PUBLIC BUILDING COMMISSION OF CHICAGO
50 WEST WASHINGTON STREET, CHICAGO, IL 60602
12th DISTRICT POLICE STATION
1412 SOUTH BLUE ISLAND AVENUE, CHICAGO, IL 60608

DESCRIPTION: UPDATED INTERIOR ELEVATION
REVISION: ADDENDUM 1

SHEET:
ASK.01

4
 A6.4 3" = 1'-0"
DETAIL @ COPING

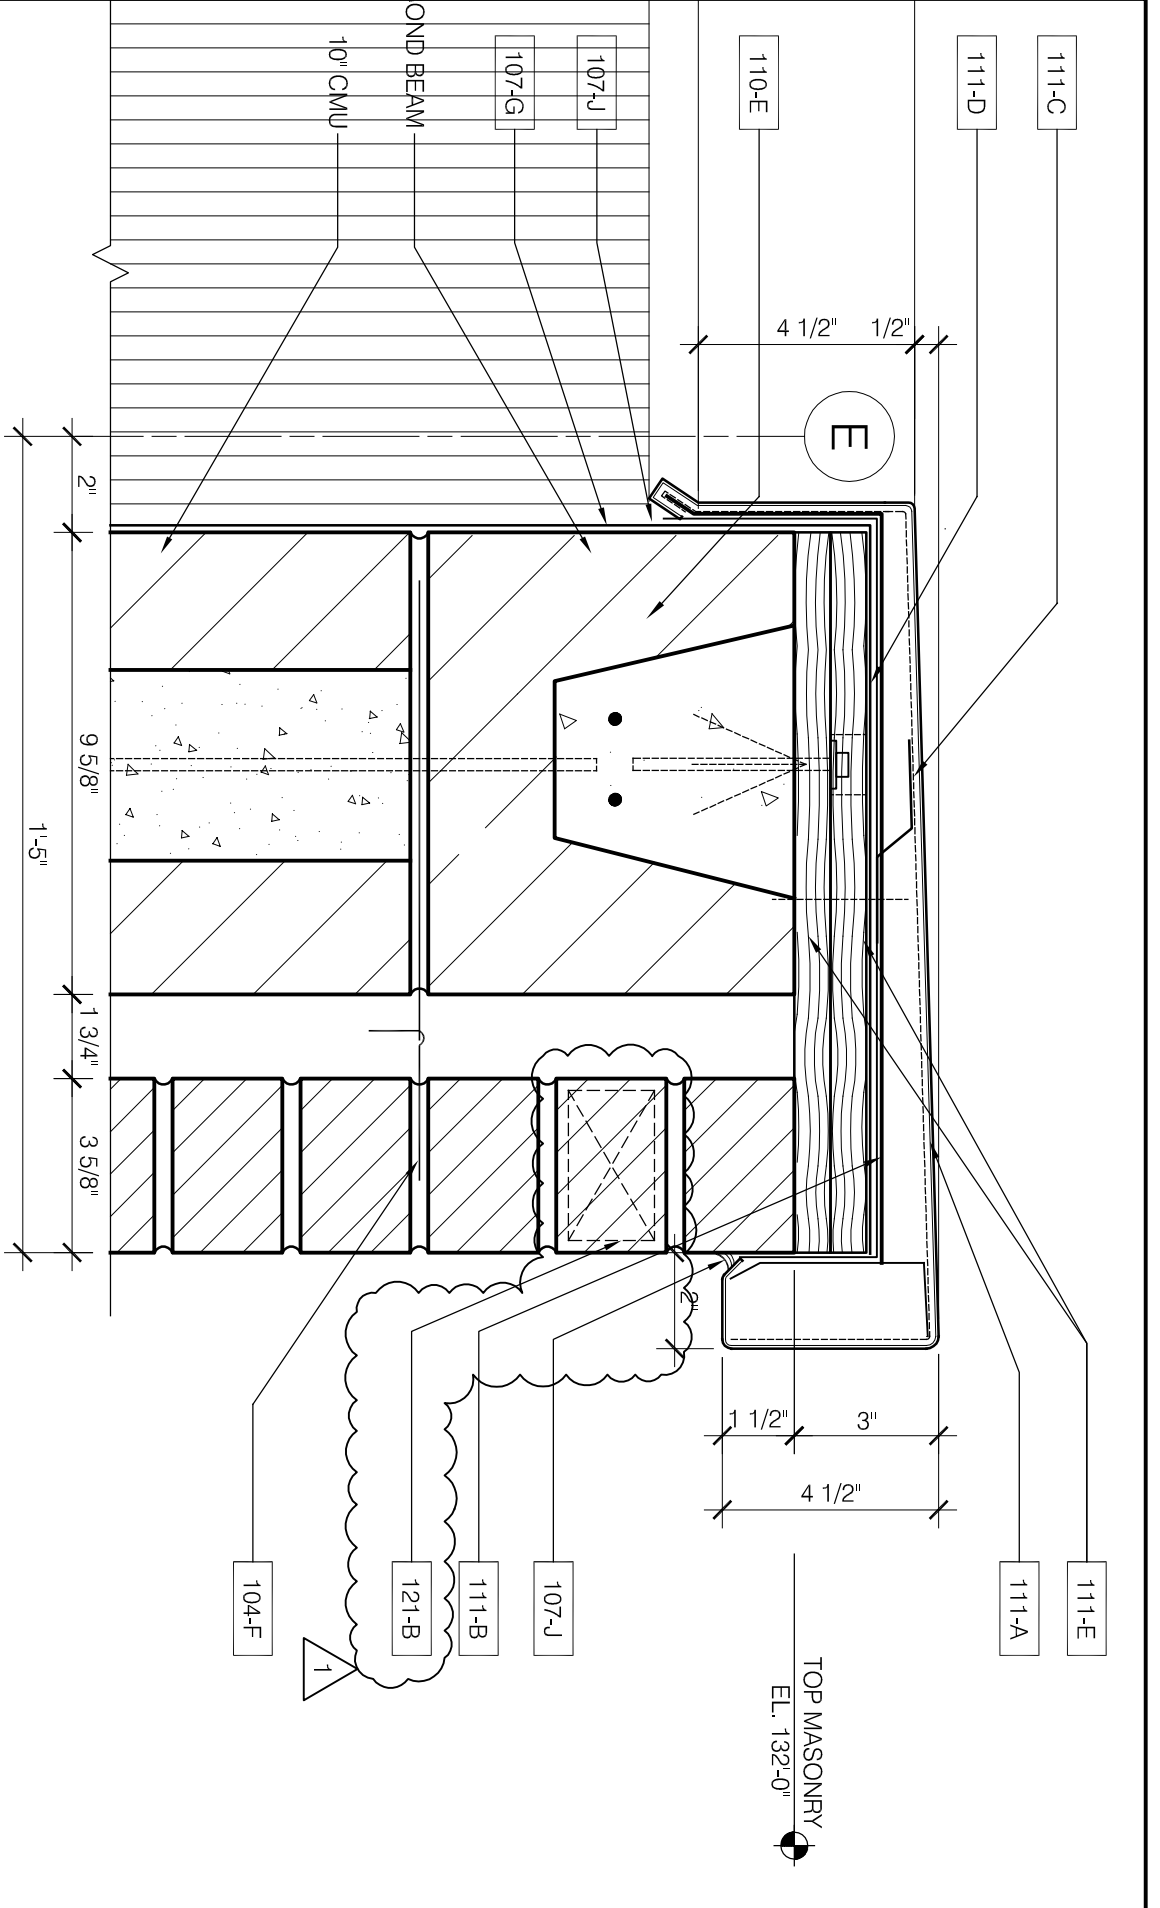
VOA PH: (312)554-1400 FAX: (312)554-1412	VOA ASSOCIATES, INC. Architecture/Planning/Interior Design 224 South Michigan Avenue #1400 Chicago, Illinois 60604	PUBLIC BUILDING COMMISSION OF CHICAGO 50 WEST WASHINGTON STREET CHICAGO, IL 60602	12th DISTRICT POLICE STATION 1412 SOUTH BLUE ISLAND AVENUE CHICAGO, IL 60608	SCALE: AS NOTED	DRAWN BY: LJH	SHEET: ASK.22
	DESCRIPTION: UPDATED DETAIL @ COPING	REVISION: ISSUED FOR ADDENDUM 1	DATE: 09/21/2010	CHECKED BY: KMC	REFERENCE: 4/A6.4

6 MILLWORK DETAILS
 A8.1 1'-1/2" = 1'-0"

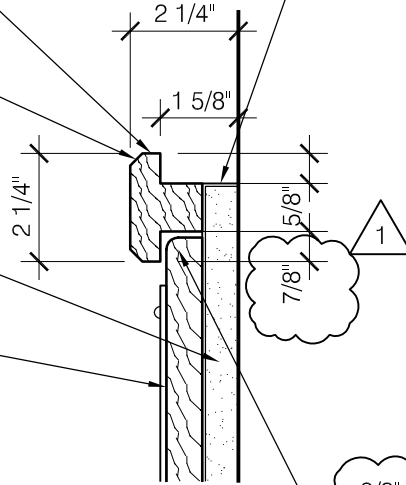
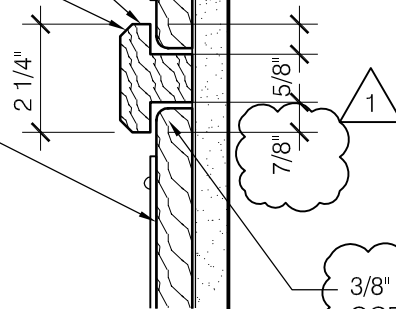
REMOVABLE CHERRY
PLAQUE W/ MOUNTABLE
CLEAR ACRYLIC PHOTO
COVER (PLAQUE SLIDES
IN FROM END)

DESCRIPTION:
UPDATED MILLWORK DETAIL

4
MASONRY SCREEN WALL
 S2.5 1/2"=1'-0"

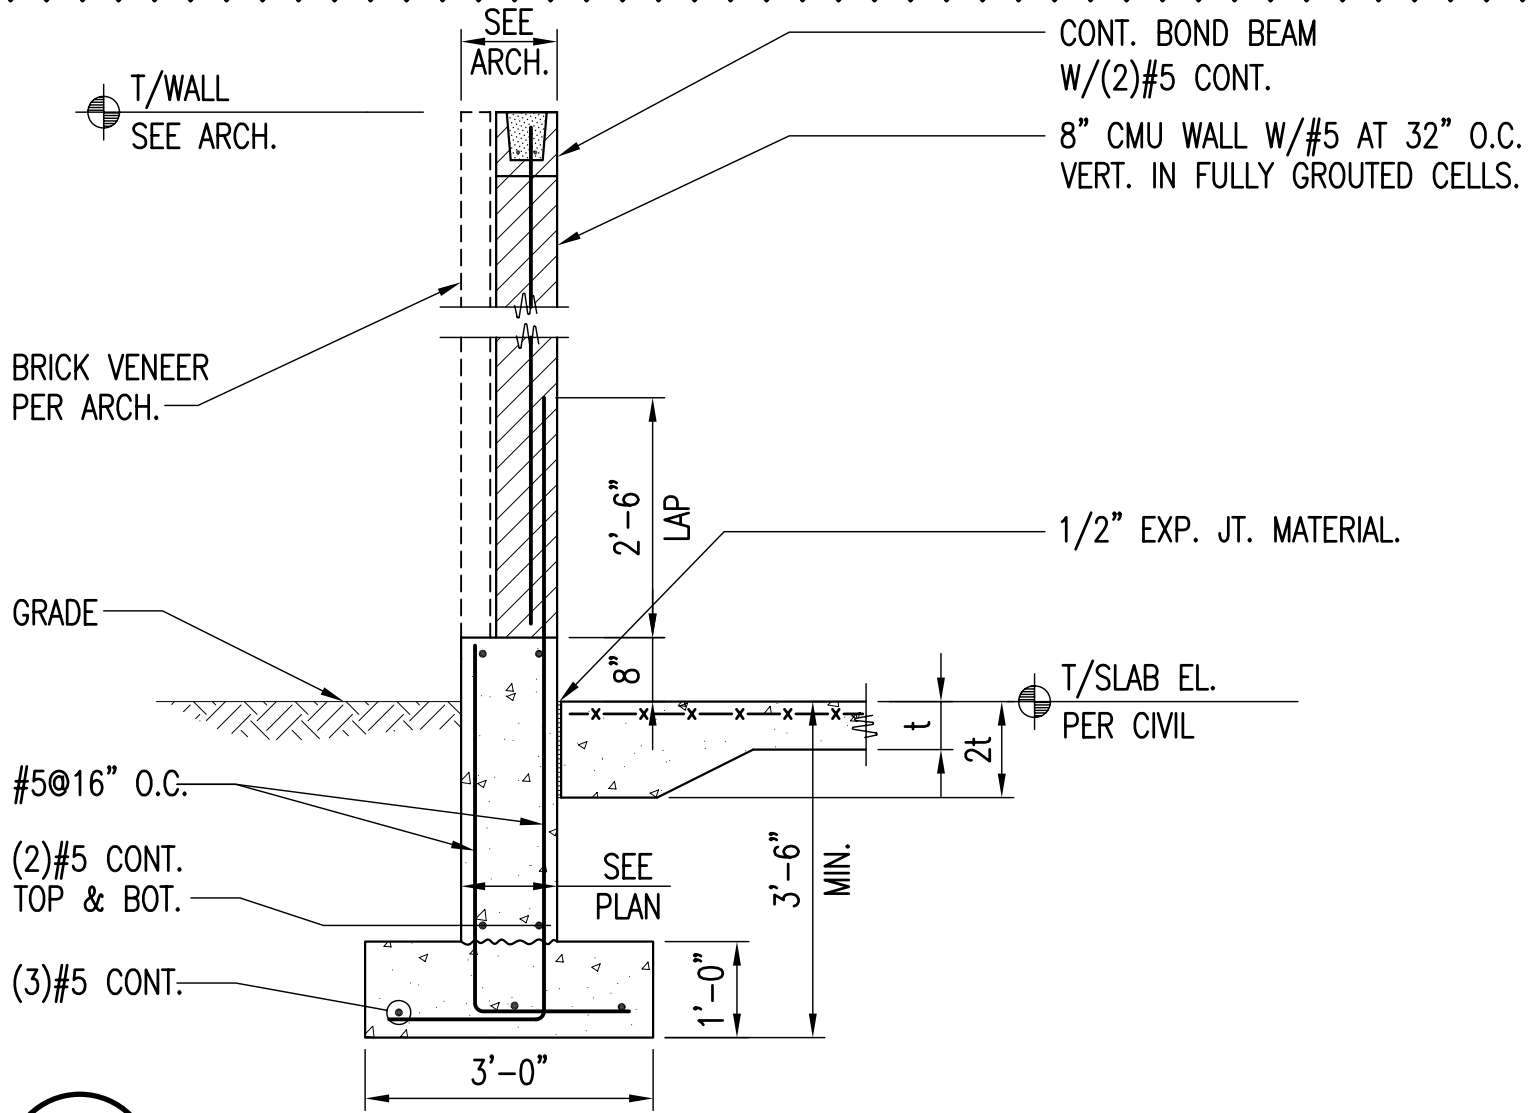
ISSUE: ADDENDUM 1
 TITLE: MASONRY SCREEN WALL
 REFERENCE: S2.5

SECTION AT TRENCH DRAIN

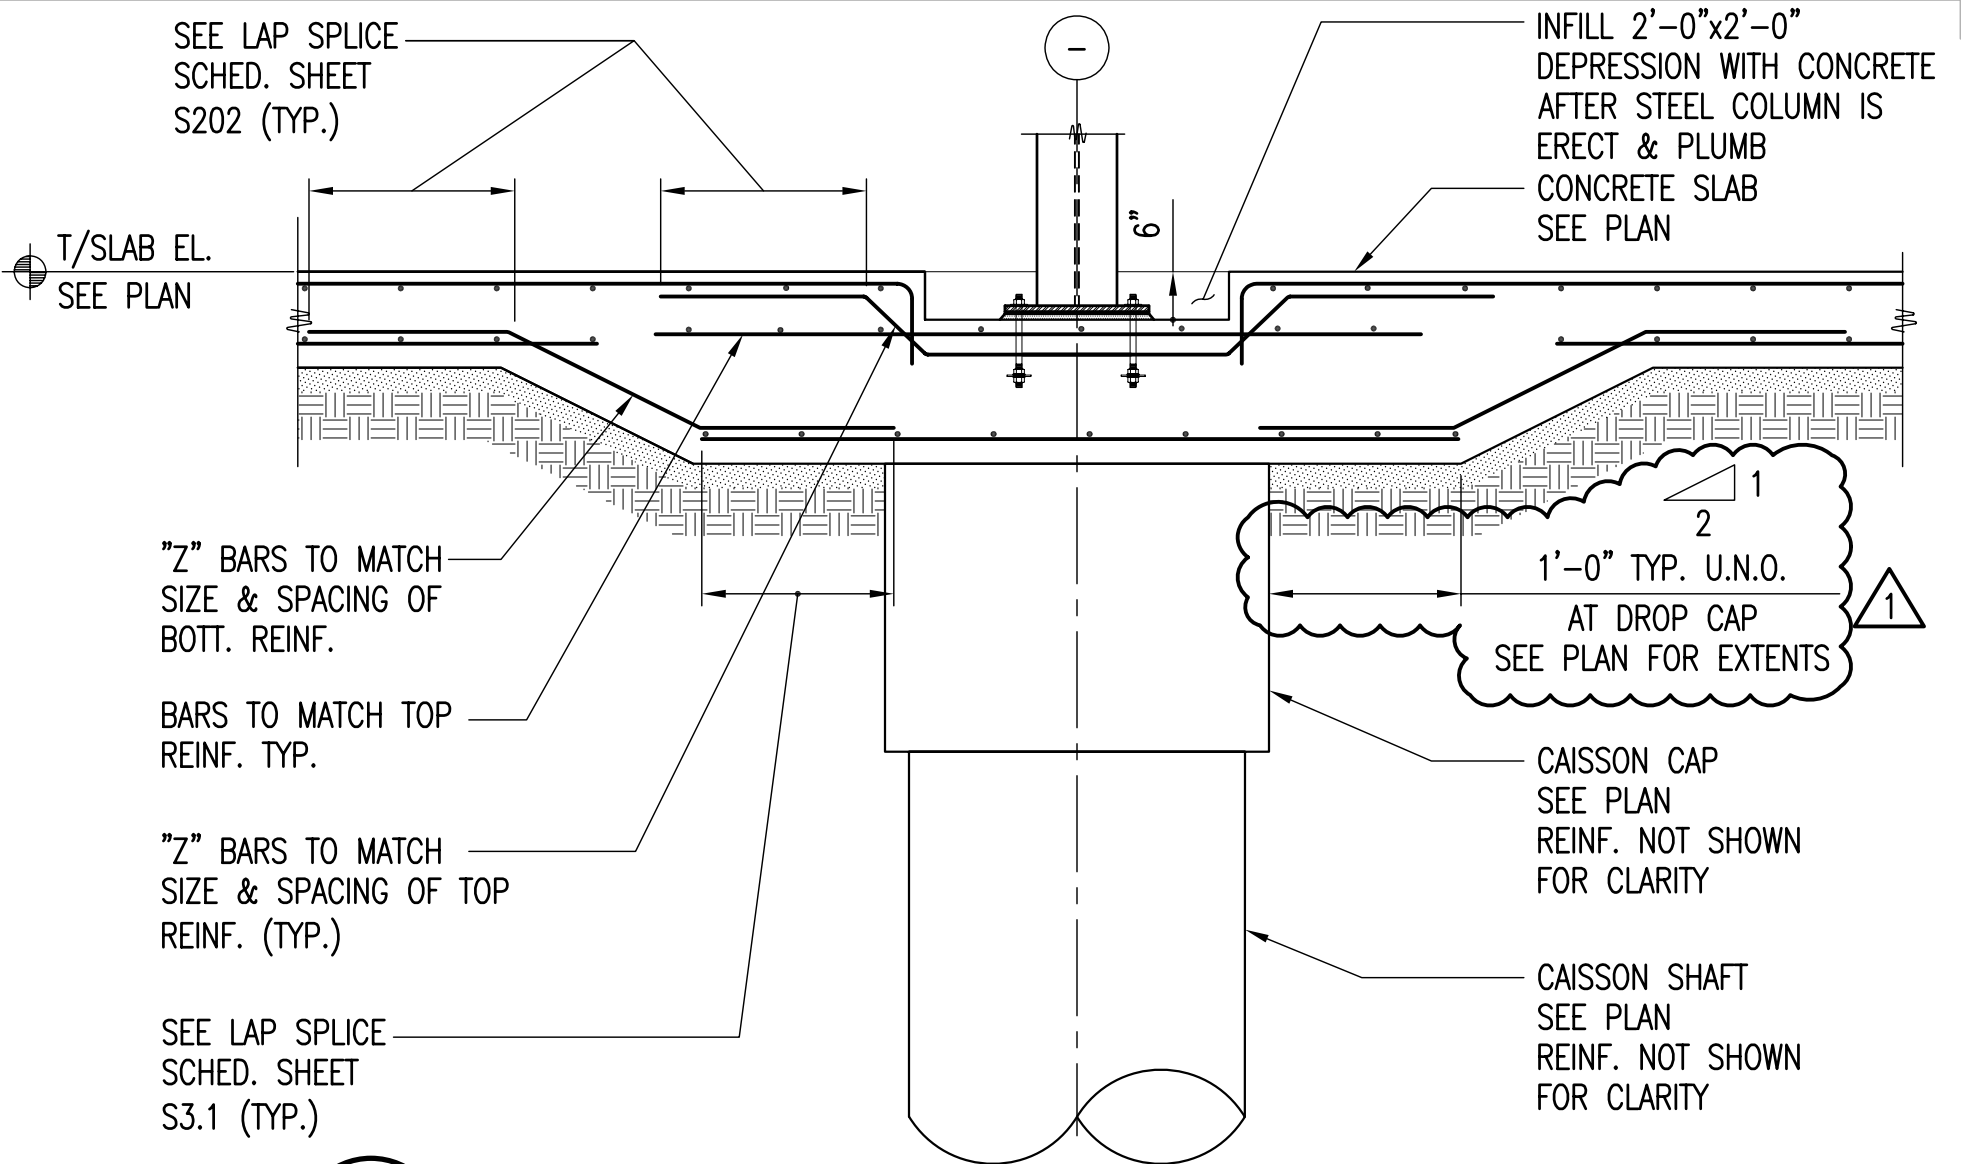
#5 DWLS SPACING TO
MATCH SLAB REINF.

CONT. #5 AT 12" O.C.
(MIN. 3 THUS)

TRENCH DRAIN SIZES &
LOCATION PER ARCH. &
PLUMBING DWGS.

TYPICAL SLAB-ON-GRADE CONTROL JOINT

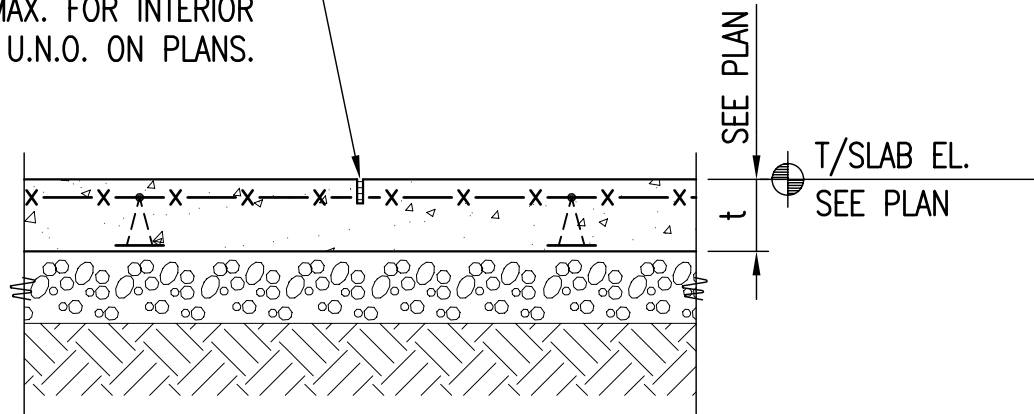
SAW CUT 1/4" WIDE x t/4 DEEP.
FLUSH W/ WATER AND FILL W/ JT.
SEALANT. SPACE CONTROL JOINTS
AT 15'-0" O.C. MAX. FOR INTERIOR
SLABS U.N.O. ON PLANS.

SAW CUT 12 HOURS AFTER SLAB IS PLACED (MAXIMUM).
SEE 1/S2.3 FOR REMAINDER

TYPICAL SLAB-ON-GRADE CONSTRUCTION JOINT

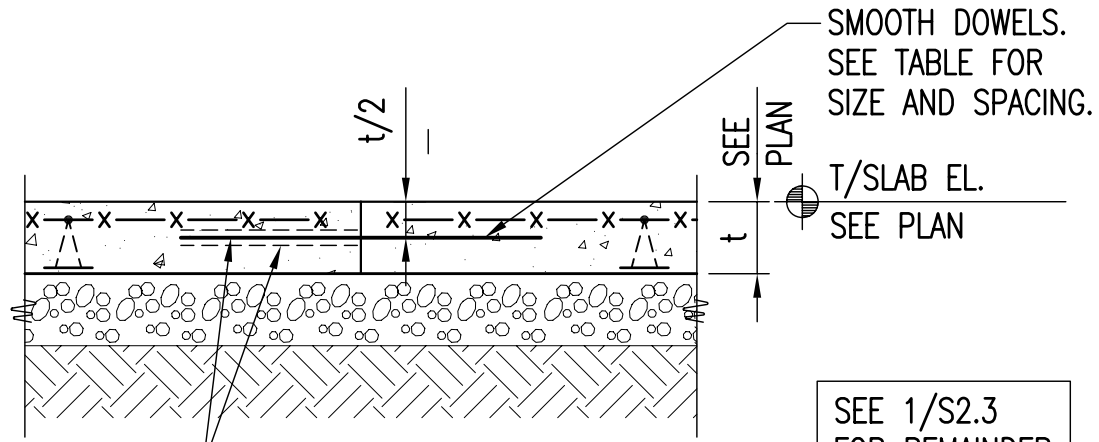
SMOOTH DOWEL SIZE AND SPACING			
SLAB DEPTH (IN)	DOWEL ϕ (IN)	DOWEL LENGTH	DOWEL SPACING
5" TO 6"	3/4"	2'-6"	1'-6" O.C.
7" TO 8"	1"		
9" TO 11"	1 1/4"

USE PLASTIC SLEEVE OR GREASE COAT ONE END TO PREVENT BOND TO CONCRETE.

1 REFERENCE DRAWING: P12 (PLUMBING-SECOND FLOOR PLAN)
SCALE: 1/8" = 1'-0"

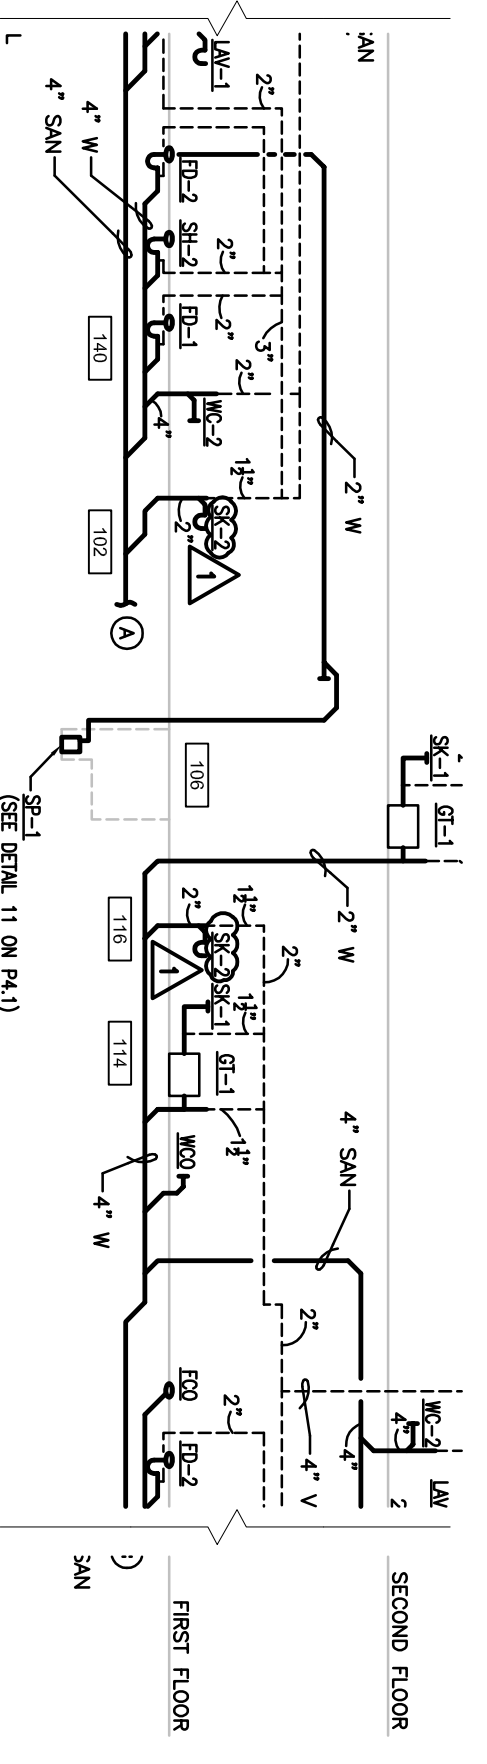
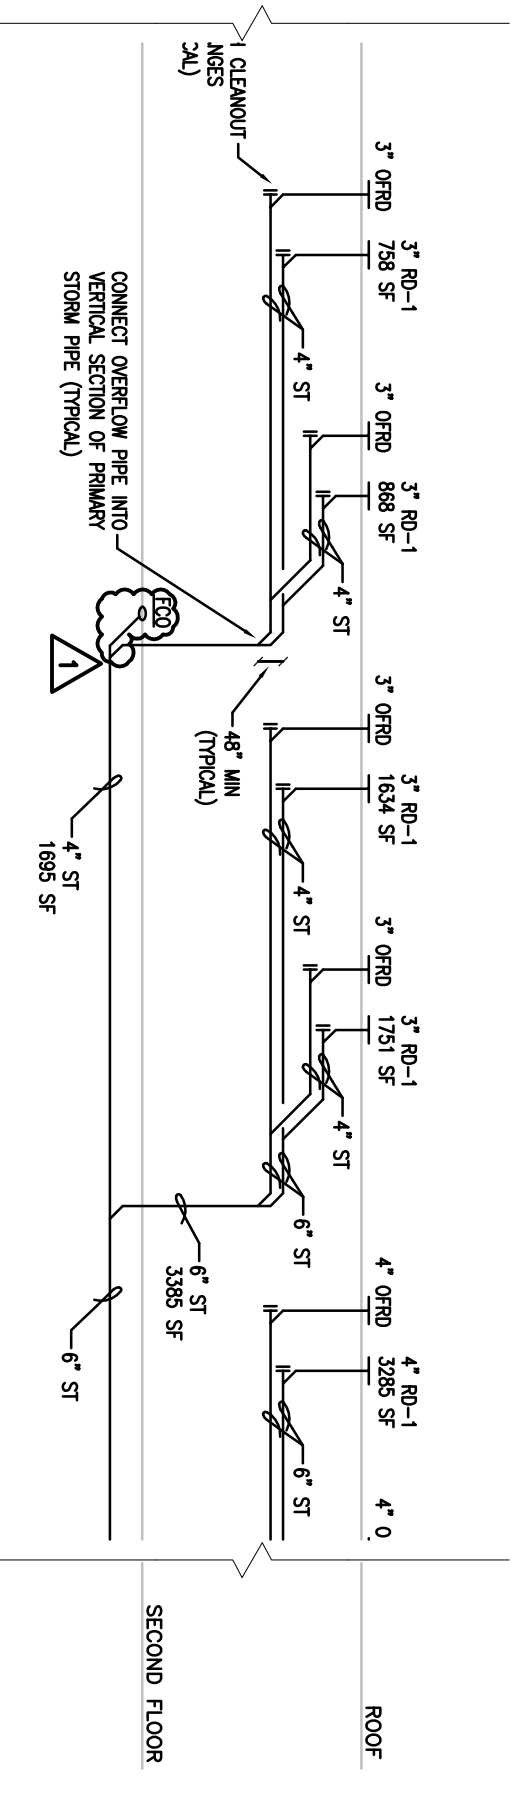
3. THE COLD WATER PIPING FROM THE RAINWATER DAY TANK TO THE URINALS AND WATER CLOSETS SHALL BE COPPER WITH 1" INSULATION. PAINT THE INSULATION AND PIPING YELLOW AND ADD "NON-POTABLE" LABELS AT INTERVALS NOT TO EXCEED TEN FEET.
4. COORDINATE ALL PLUMBING WORK WITH MECHANICAL WORK.
